Department of Environmental Quality

RE: Approval of 1,000 gallon septic tank

DRN EYLM 7/96	CHK BY
APP BY	
TETON GARD & CARAPICOS EVANSTON, WYOMING 82922-2103	
LINE DESCRIPTION	
1,000 GALLON TWO PIECE SEPTIC TANK	
REF. P & I.D.	CLIENT
REF. PLAN	Eltingford Brc
DWG. NO.	SEPTIC-1

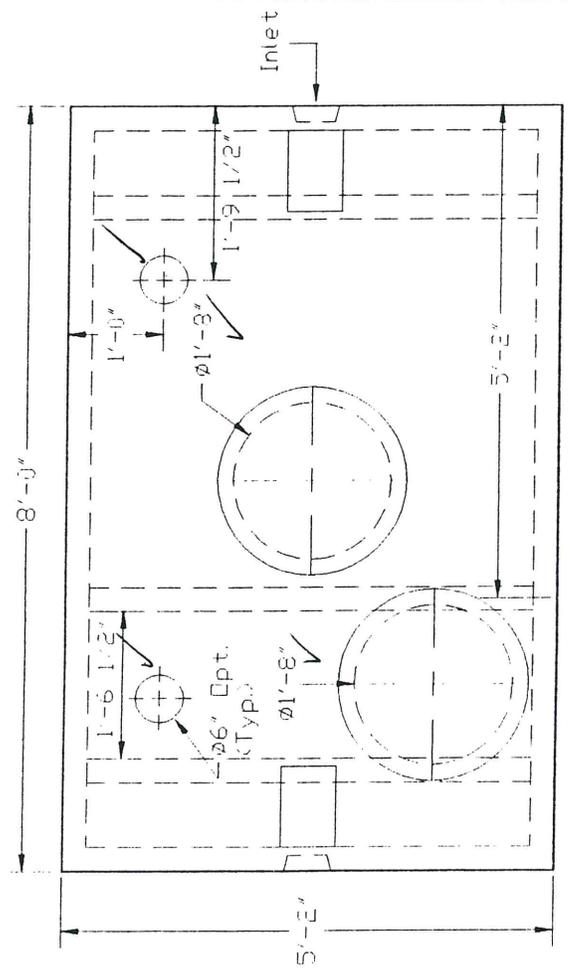
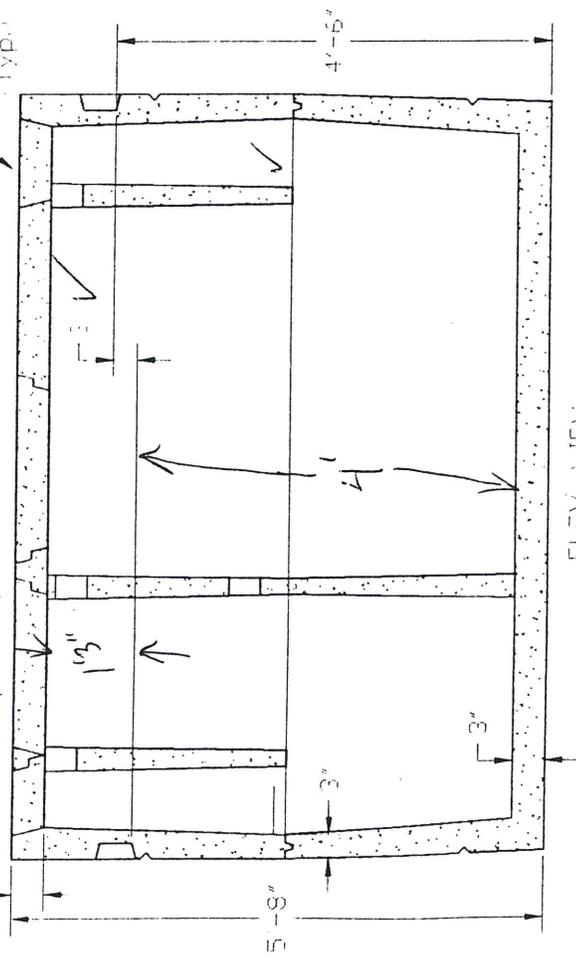
The plans you submitted for manufacturing of a 1,000 gallon septic tank have been reviewed by this office of the DEQ/WQD. It has been determined that the proposed plans meet the requirements of the Wyoming Water Quality Rules and Regulations, Chapter XI, Section 39. Tanks manufactured by Ellingford Brothers according to the submitted design will be added to the Wyoming DEQ list of approved 1,000 gallon tanks.

When these tanks are installed risers will need to be installed from both manholes, or from both of the cleanout access ports to allow access from above the ground surface.
